Hi-Fi Products
Service Bulletin

Model: DTC-75ES/55ES

No. 166

Subject: Intermittent No Loading or No
Ejecting

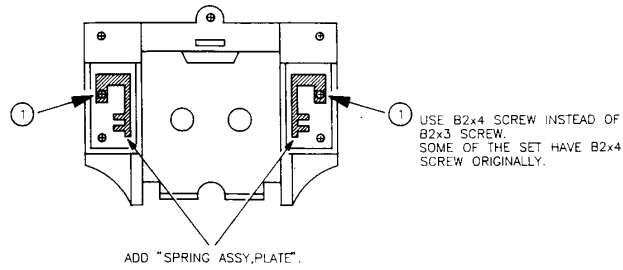
Symptom:
(62)

Cassette loads and/or ejects intermittently.

Solution: If this symptom occurs, please add two spring steel plates
as shown below:

Description	Part Number
Spring Assembly, Plate	X-3362-655-1
